**ADDENDUM NUMBER 1**  
**2021 SIDEWALK REPAIRS ESTATES AND SOUTHAMPTON**  
**PROJECT NUMBER PW-2021-01**  
**02/08/2021**

2021 SIDEWALK REPAIRS  
ESTATES AND SOUTHAMPTON

DETAILS &  
SCHEDULES

Sheet Title	AS NOTED
Scale	AS NOTED
Designed by	SAL
Drawn by	SAL
Sheet No.	C104
Date	JAN 10, 2021
Filename	2021 SIDEWALK REPAIRS

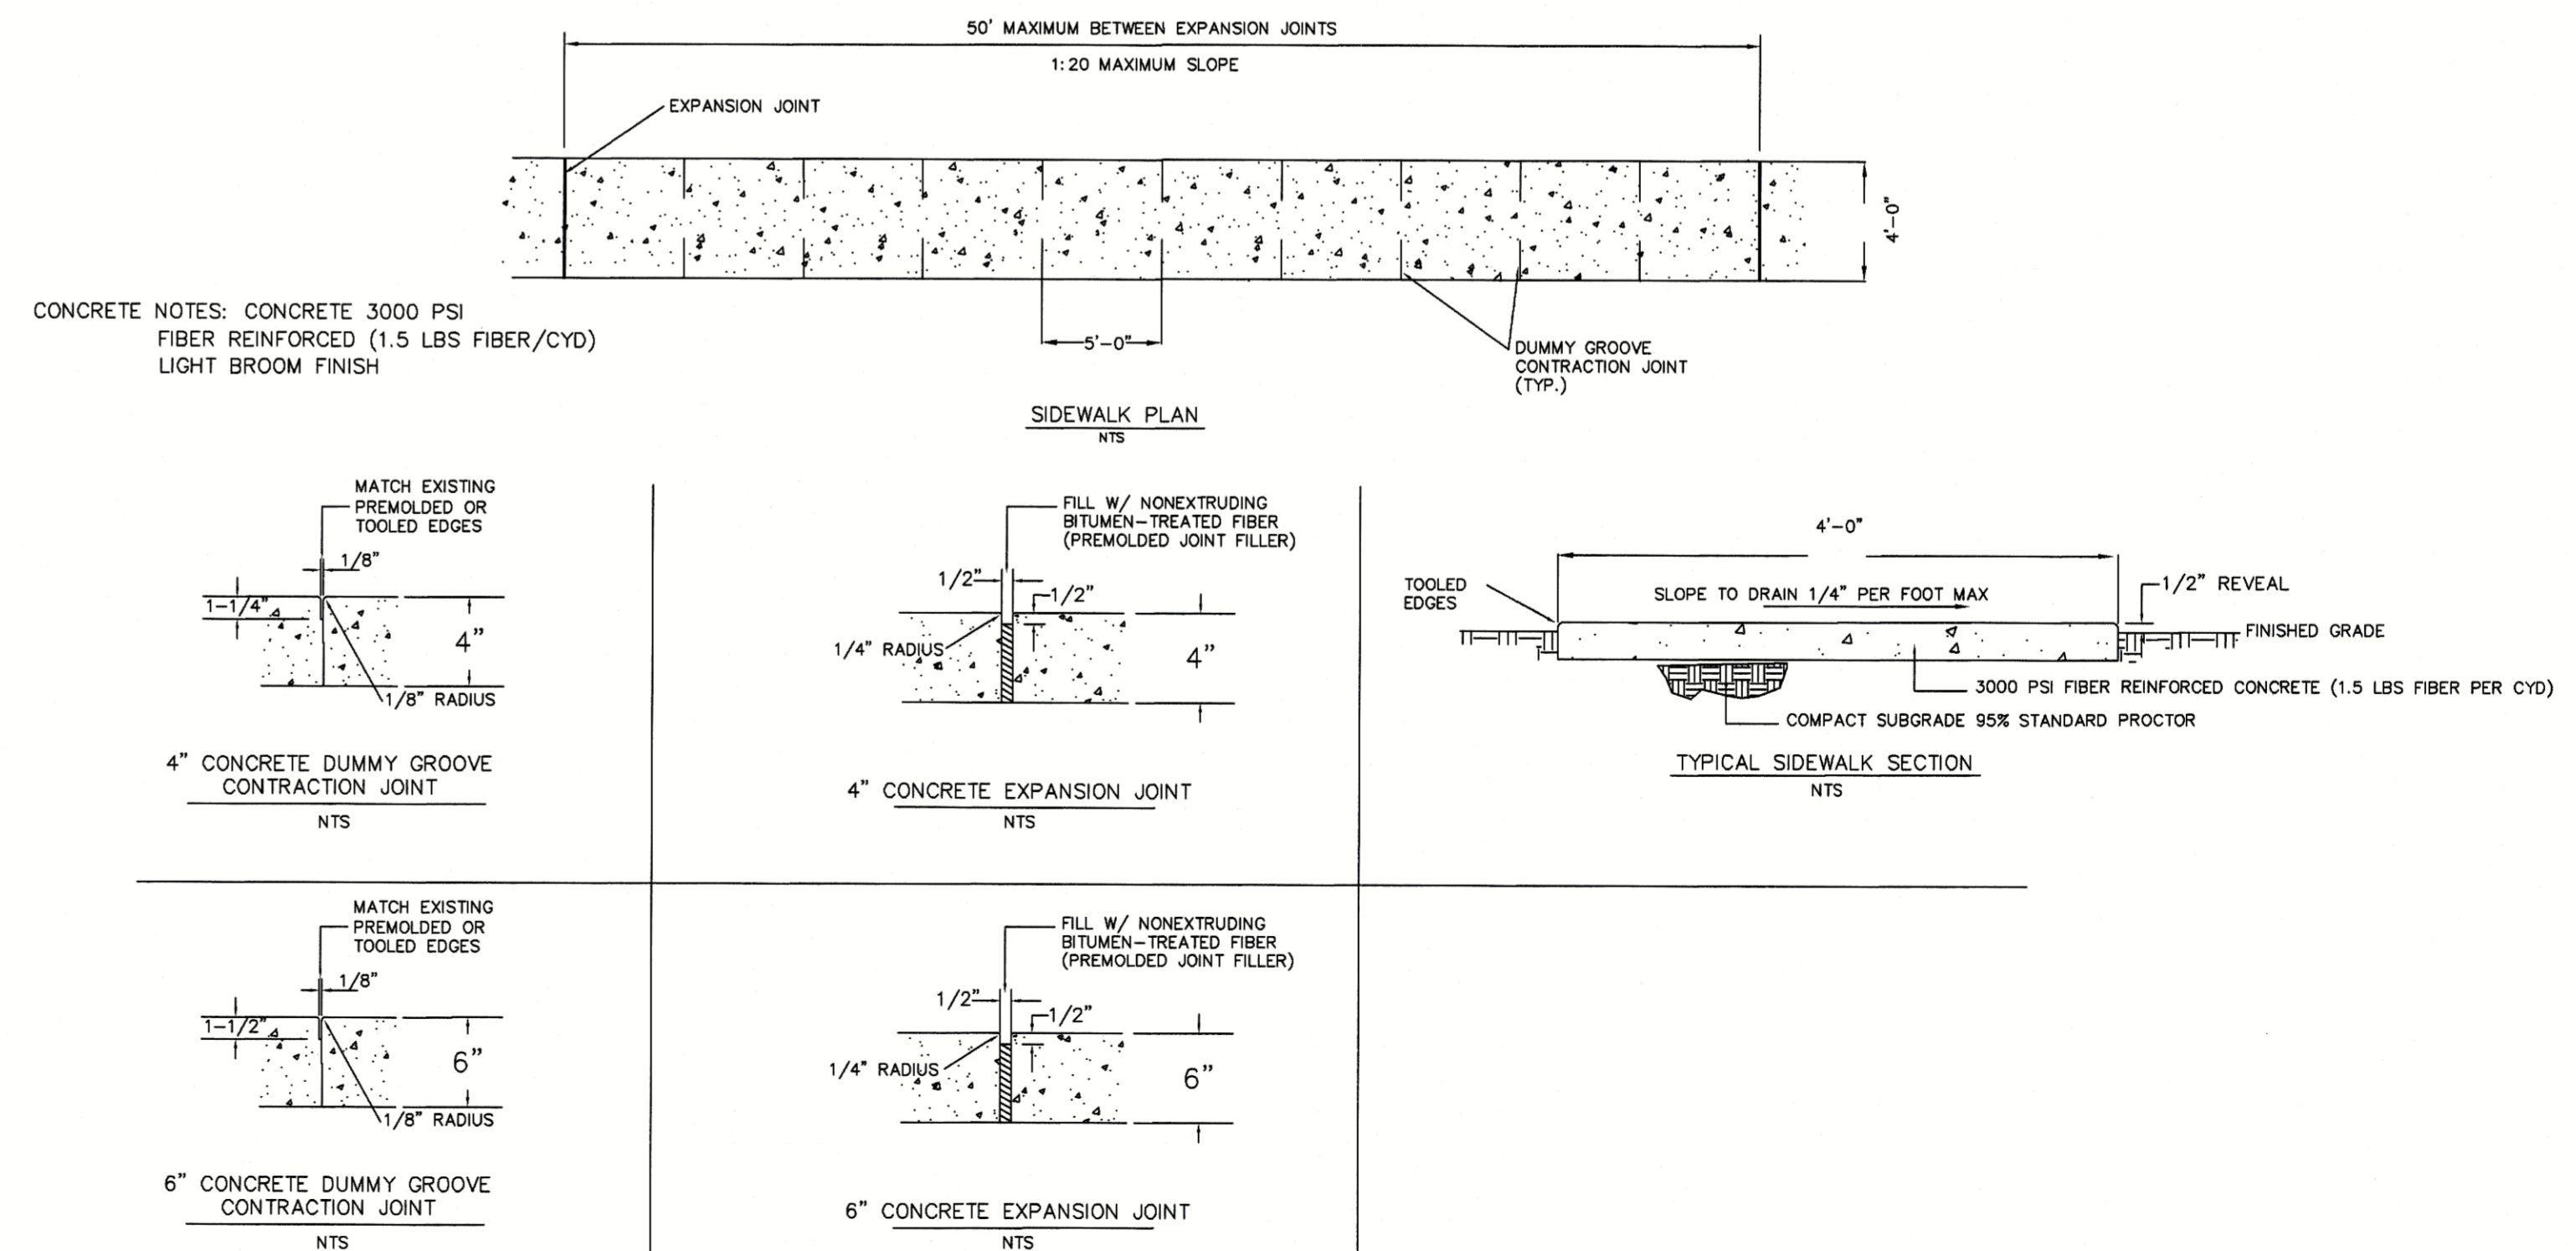
1. Bidders are reminded to comply with all the requirements for bidding as enumerated in the Project Manual, INCLUDING ACKNOWLEDGEMENT OF THE RECEIPT OF THIS ADDENDUM ON THE BID FORM.
2. Reference is made to Drawing Sheet C104. Delete Sheet C101 and replace with the attached revised Sheet C104. Change includes deleting 460 Carriage Oaks S1 Sidewalk and replacing it with 294 Carriage Oaks S1 Sidewalk. This change also included a change in the dimensions of sidewalk "S1".

SECTION NUMBER	LOCATION	LINEAR FEET	SQUARE FEET	SPECIAL NOTES
S1	294 CARRIAGE OAKS	9.3	37.2	ADDENDUM 1
S2	412 CARRIAGE OAKS	7	28	
S3	412 CARRIAGE OAKS	14.5	87.5	6" THICK AND 6 FEET WIDE @ PUMP STATION DRIVEWAY
S4	300 WYNFIELD DRIVE	4	16	
S5	123 BRUNSWICK DRIVE	12.25	49	
S6	206 BRUNSWICK DRIVE	32	128	
S7	102 VILLAGE GREEN @ MANHOLE	7	28	EXPANSION JOINTS @ MH AND TO EXISTING SIDEWALK
